**GENOA CHARTER TOWNSHIP
PLANNING COMMISSION
PUBLIC HEARING
NOVEMBER 13, 2023
MONDAY
6:30 P.M.
AGENDA**

Attention:	Amy Ruthig, Planning Director
Subject:	Mister Car Wash – Special Land Use and Site Plan Review #2
Location:	1015 Latson Road – east side of Latson Road, south side of Grand River Avenue
Zoning:	GCD General Commercial District

**Re: Mister Car Wash
Site Plan Review No. 2**

NORTH ELEVATION
 SCALE: 3/16" = 1'-0"

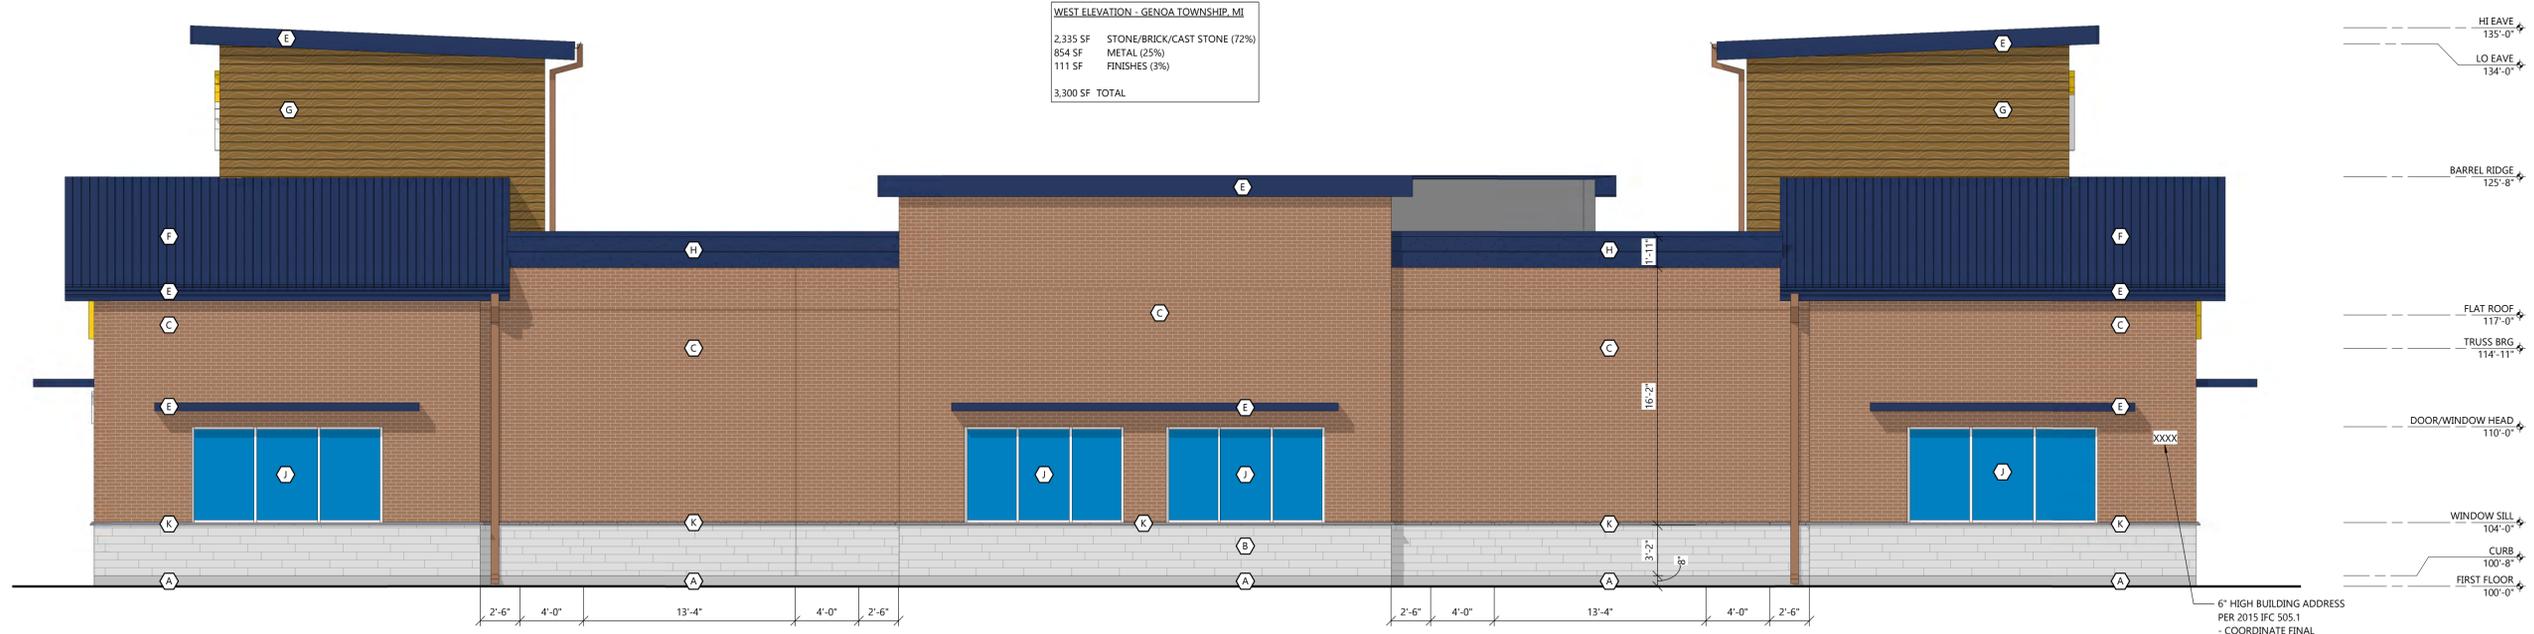
The revised submittal includes material calculations that generally demonstrate compliance with the standards of Section 12.01; however, the west elevation provides 72% brick/stone, while a minimum of 75% is required.

Lastly, Section 12.01 requires the use of earth tone colors. The revised submittal has reduced the amount of bright blue, though it still remains as a prominent color element (in particular for the canopy).

DESIGNED BY: ST
 DRAWN BY: ST
 CHECKED BY:
 SCALE: 1" = 20'
 JOB NO: 21-519
 DATE: 10/04/2023
 SHEET NO. **5**

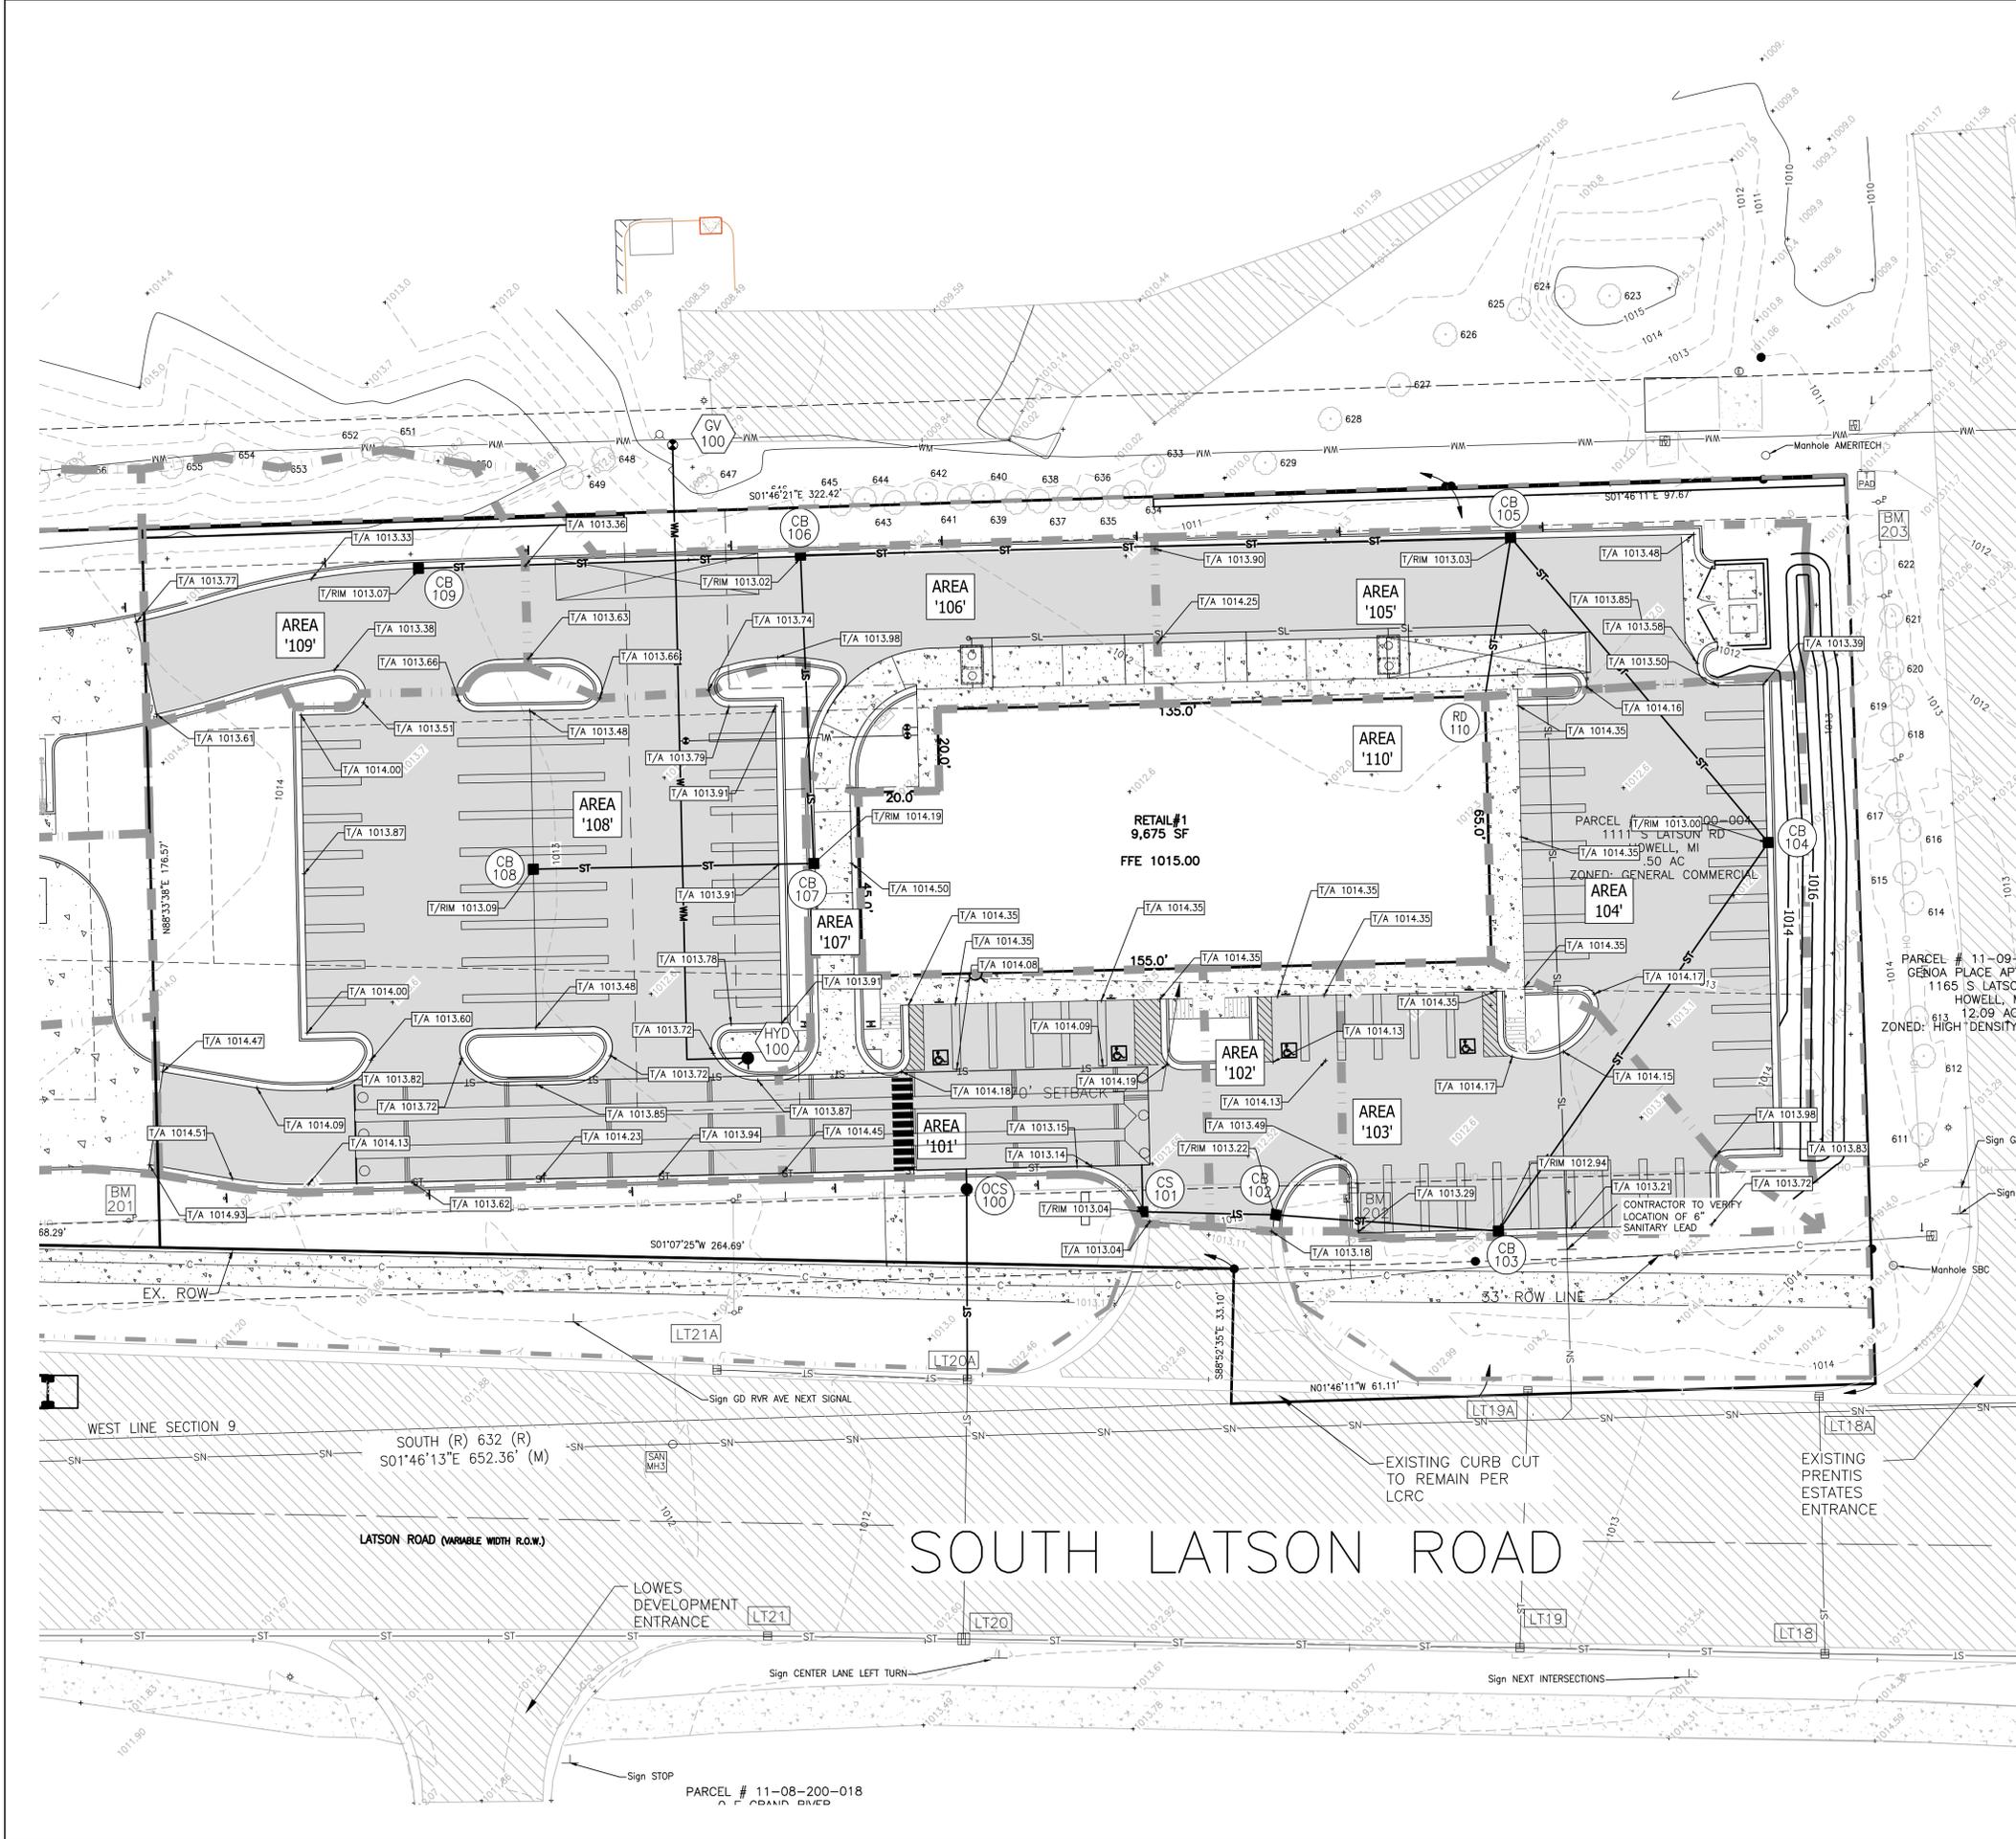
2. The building address shall be a **minimum of 6"** high letters of contrasting colors and be clearly visible from the street. The location and size shall be verified prior to installation. Provide clarification on building addressing. It is recommended that each tenant space have an individual address. **(Noted on Sheet 5 General Note 3)**

3. Two-way emergency vehicle access roads shall be a minimum of 26-feet wide. With a width of 26-feet, one side (building side) of the drive shall be marked as a fire lane. Include additional signage along curblines at least every 50-feet. Access roads to the site shall be provided and maintained during construction. Access roads shall be constructed to be capable of supporting the imposed load of fire apparatus weighing at least 84,000 pounds, this includes over the underground retention. **(Noted on Sheet 5 General Note 6 & 7)**

6. A Knox box shall be installed adjacent to the main entrance of the structure, in a location coordinated with the fire authority. **(Noted on Sheet 5 General Note 4.)**

7. During the construction process, the building will be evaluated for emergency responder radio signal strength. If coverage is found to be questionable or inadequate; the contractor or the building owner shall hire an approved contractor to conduct a grid test of the facility. If the signal strength coverage is found to be non-compliant, an approved emergency responder radio coverage system shall be provided in the building. **(Noted on Sheet 5 General Note 9)**
